To: Development Permit Panel
From: Brian J. Jackson, MCIP
Director of Development
Date: February 10, 2011
File: DP 10-540948
Re: **Application by Yamamoto Architecture Inc. for a Development Permit at 7491 /
7531 and 7551 No. 2 Rd.**

Excerpt from the Minutes from
The Design Panel Meeting

1. **DP 10-540948 – 14 UNIT TOWNHOUSE DEVELOPMENT**

BUILDING NO. 1
SECOND FLOOR PLAN
SCALE: 1/8" = 1'-0"
CEL. NO. 8-47

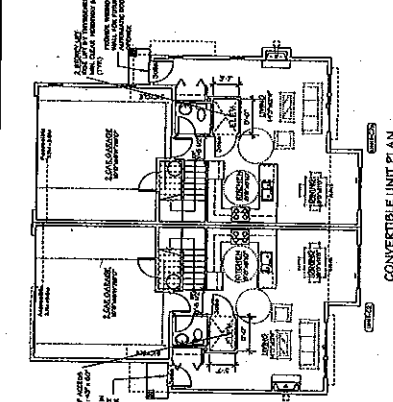
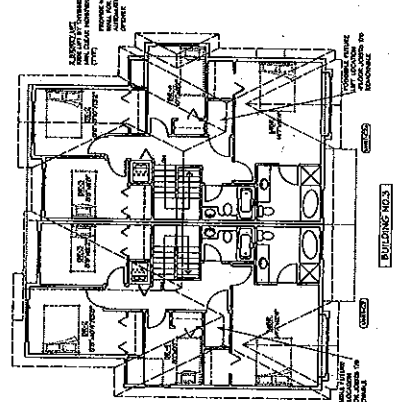
1. *design development to increase fenestration through (i) provision of more windows in north elevation of Building 2, and (ii) addition of windows and changes in the siding at the south elevation of Buildings 1 and 3;*

7. *investigate whether the garbage and recycling enclosures at the side of unit B1 in Building 1 can be relocated to address possible noise, smell and safety issues;*

- Windows added to Building 2 North elevation garage and dining room.
- Windows added to Building 1 South elevation garage and dining room.
- Windows added to Building 3 South elevation garage and living room.
- Masonry proposed at the ground floor at the following locations:
 - Building 1 east elevation.
 - Building 2 east and south elevation.
 - Building 3 east and south elevation.
 - Building 4 east elevation.
 - Building 5 east elevation.

- Garbage and recycling enclosure doors are facing away from entries and is located at a convenient location for both residents and garbage/recycling pick up.

CONVERTIBLE UNIT PLAN

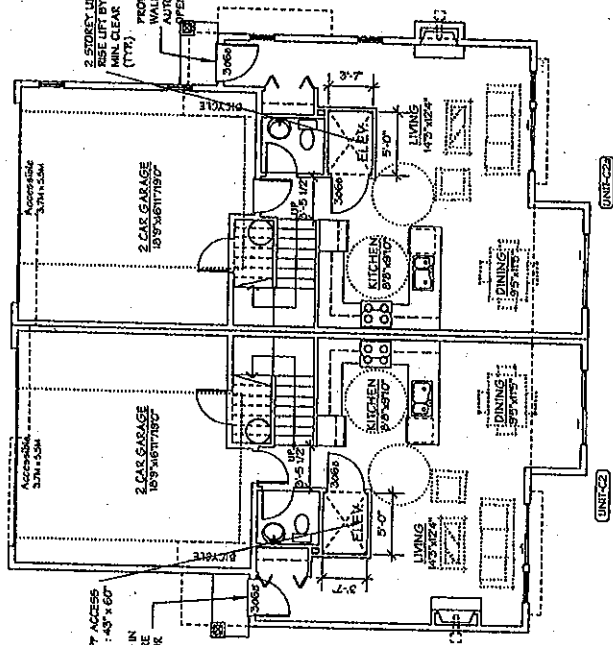
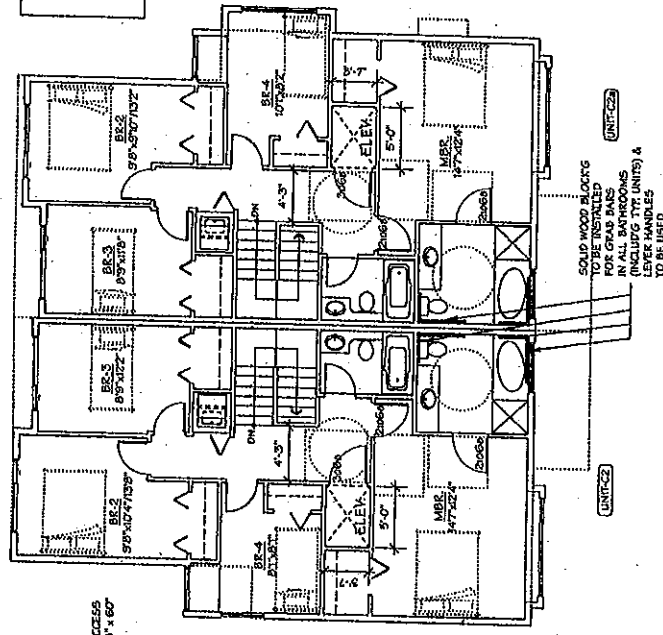
- A convertible unit plan has been provided for two units (units C2 and C2a) that would accommodate accessible access including provision for an elevator. Staff have requested notations on the plans for removable joists and adjustments to the concrete floor pad in the area planned to accommodate the potential elevator.

5. *consider convertibility of all two-storey buildings;*

- Two convertible units proposed.
